Architectural Review Board

SUBJECT: New Business – Item 7
15 W. Stong St
NHPD / PC-1
New Construction

Covington Place
15 West Strong Street
Pensacola, FL 32501

SHEET TITLE
ENLARGED
ELEVATIONS

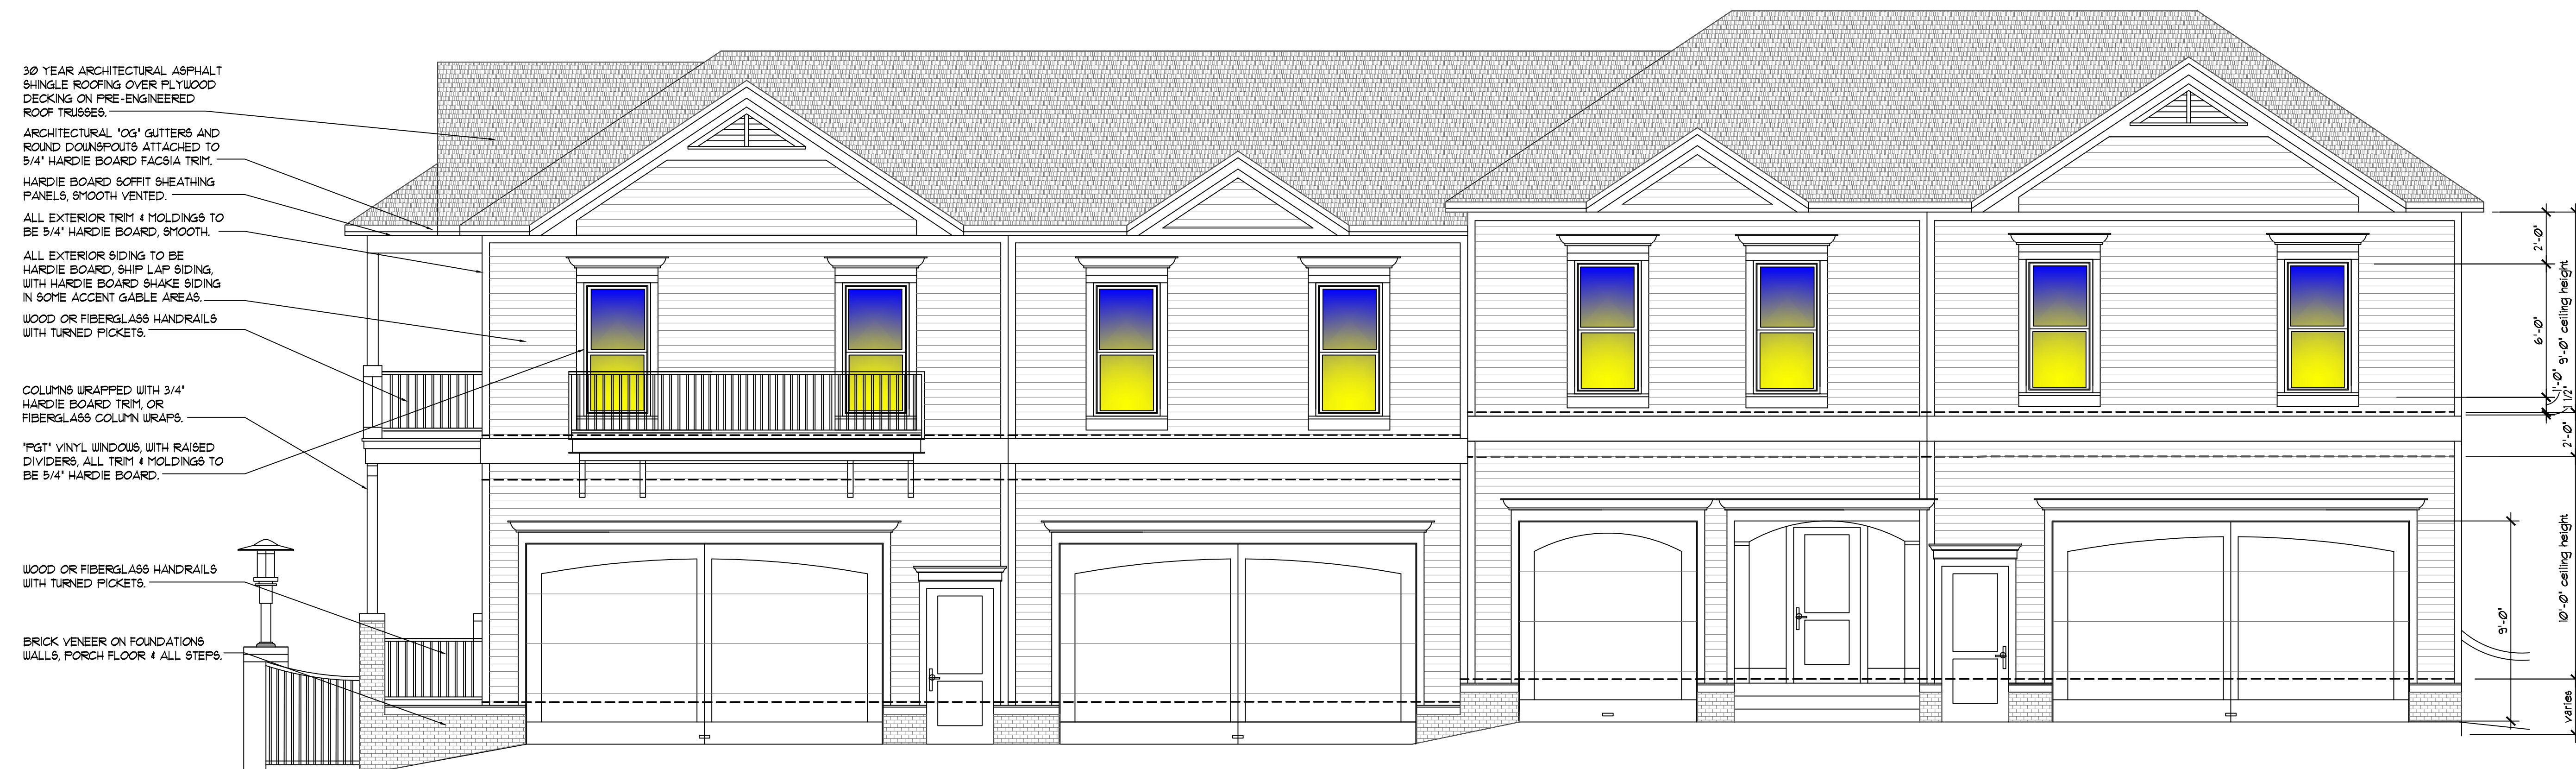
Mr. Townes addressed the Cervantes elevation. Mr. Kunze advised he tried to make the gables more inviting. Wrought iron gates will be built on the Cervantes side at the driveway exit and entrance to the green, which will have some type of fountain. Mr. Townes was concerned with Buildings 9 and 18 being flat and unadorned. He suggested anything to differentiate the building line on the Cervantes Street side, possibly pulling it in and making it smaller. Mr. Mead asked if they were considering block panels with brick piers or pilasters for the wall gates. He advised at least two gables on the larger buildings along Cervantes would help. Mr. Kunze was agreeable to those suggestions. Mr. Jones agreed that Cervantes would be very visually prominent to the community.

Mr. Mead made a motion to approve the plan with the following changes: an addition of a south facing gable for the Cervantes façade on the western most and central building ends facing Cervantes (townhouse 9 & 18); approval of the fence with brick piers and appropriate stone caps with block or brick with some manner of planting to green the wall with ivy or appropriate vines. Ms. Campbell seconded the motion. Chairman Quina asked if the block was skim coated, and Mr. Mead clarified it would be skim coated. Mr. Jones asked about the brick pavers, and Mr. Liberis stated the actual sidewalks would be concrete, the steps and porch floor of the first floor would be brick veneer, but there could be a brick edge between the sidewalk and the front step. Also, the driveways between the units would be asphalt. Chairman Quina thanked the applicant for being transparent with the neighborhood and having a preliminary review. The motion then carried unanimously.
